## 1 Products affected

## 2 Type of change

Product Change Notification					PCN Fusedrawer 2		D10-017-137
owner	creation date	release date	released by	change order no	rev	page	
sariogar	21.09.2017	22.09.2017	buerglal	2013754	C	1 of 3

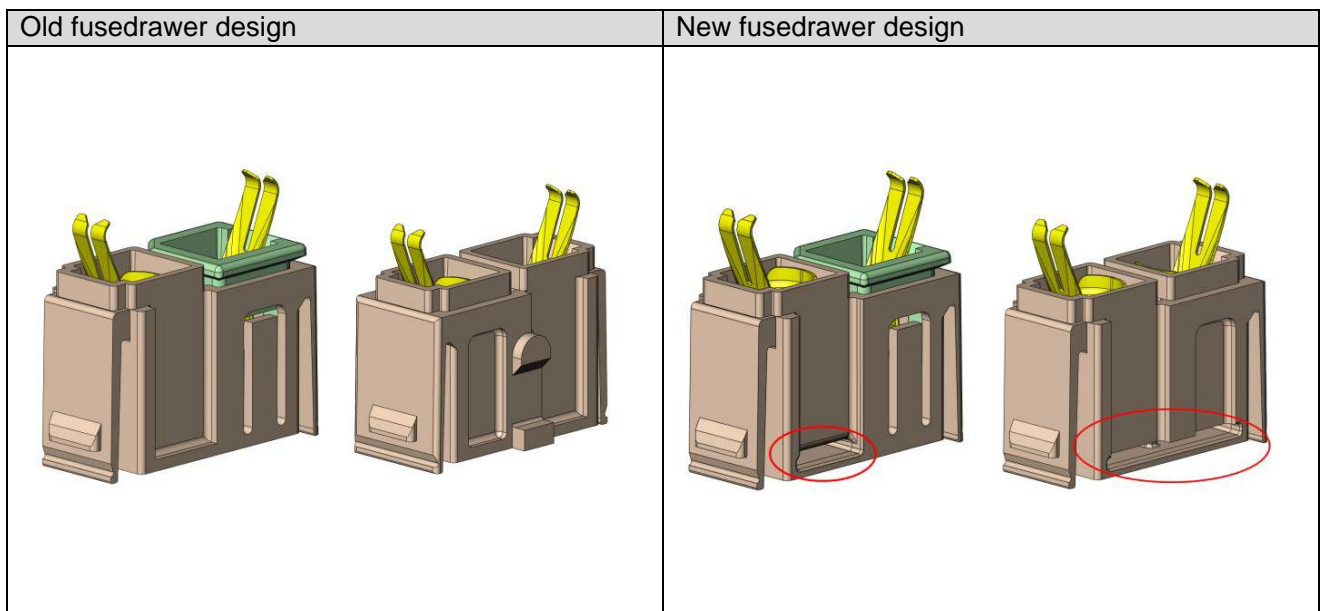
Change of plastic material from PBT+PC to PBT (Fuseholder and voltage selector)

Change of fusedrawer design (additional air gap)

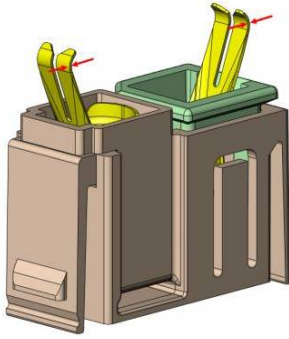
Old contact spring thickness 0.20 mm	New contact spring thickness 0.25 mm

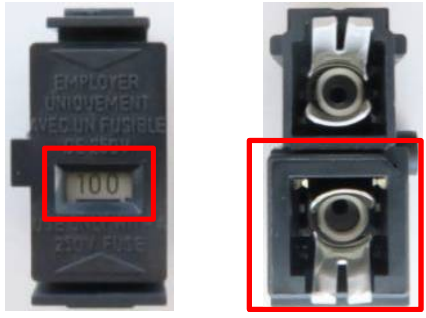
Old voltage selector insert white	New voltage selector insert changed to black colour

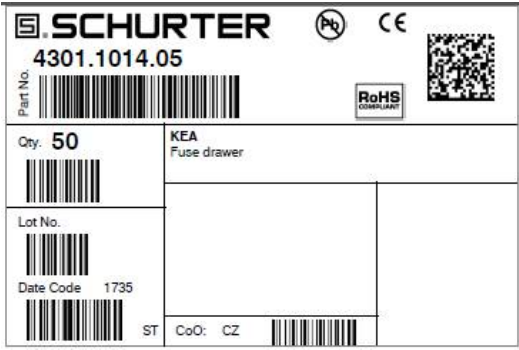
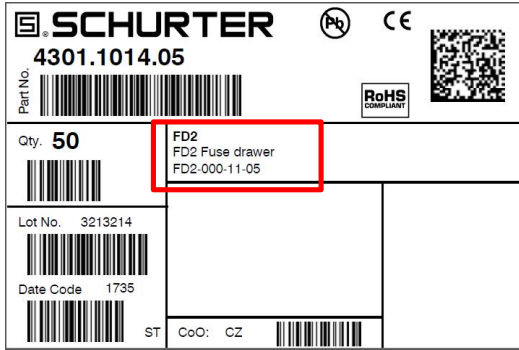
Old label	New label
	<p>Name and description adjusted. Configuration code added.</p>
